DEVELOPMENT REVIEW BOARD REPORT

CASE NUMBER/ PROJECT NAME	52-DR-2005 Windstone Townhomes		
LOCATION	4002 N. Kalarama Avenue, south of Indian School Road near 78 th Street		
REQUEST	Request approval of a site plan and elevations for a townhouse development on a 1.2+/- acre parcel. (A companion case requesting preliminary plat approval, 7-PP-2005 is being considered separately.)		
OWNER	Kalarama LLC 602-763-4668	ENGINEER	Neil/McGill Consultants 602-395-1334
ARCHITECT/ DESIGNER	Holly Street Studio 602-258-8555	APPLICANT/ COORDINATOR	Kevin Corrigan Kalarama LLC 602-763-4668
BACKGROUND	<p>Zoning. The site is zoned Multi-family Residential (R-5) District which allows development of multi-family buildings including townhouses, with densities of up to 23 dwellings per acre. The R-5 District provides for both common and private open space.</p> <p>Context. The site is located along East Main Street at Kalarama Avenue. Adjacent Uses:</p> <ul style="list-style-type: none">• North: Existing apartment building with frontage on First Avenue with R-5 District zoning.• South: Main Street and multi-family homes with R-5 zoning.• East: Patio homes with frontage on 78th Street and R-5 zoning.• West:

BUILDING 3 BACK ELEVATION (from alley)

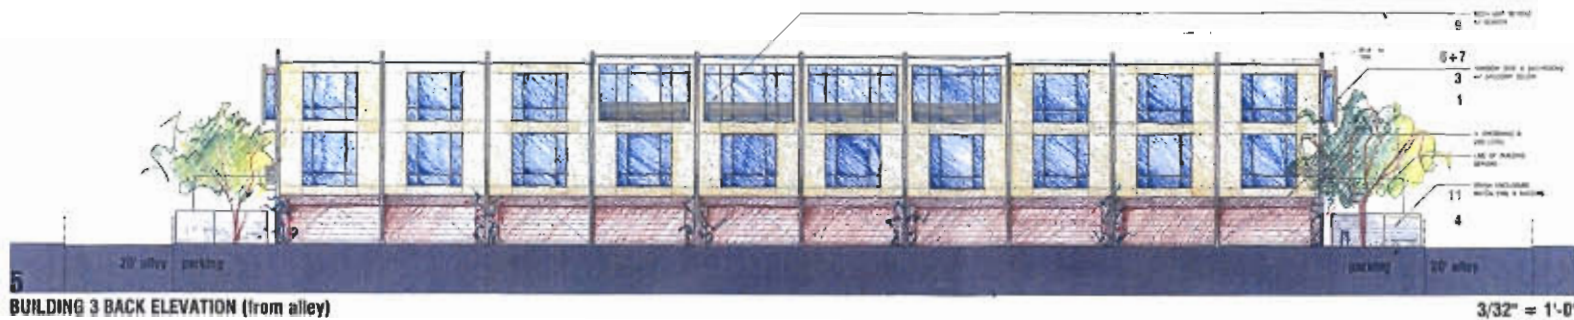
10. *All exterior doors shall be recessed a minimum of 30% of the width of the wall.*
11. *2nd floor balconies on Building 3 shall be extended outward to match the 3rd floor balconies.*
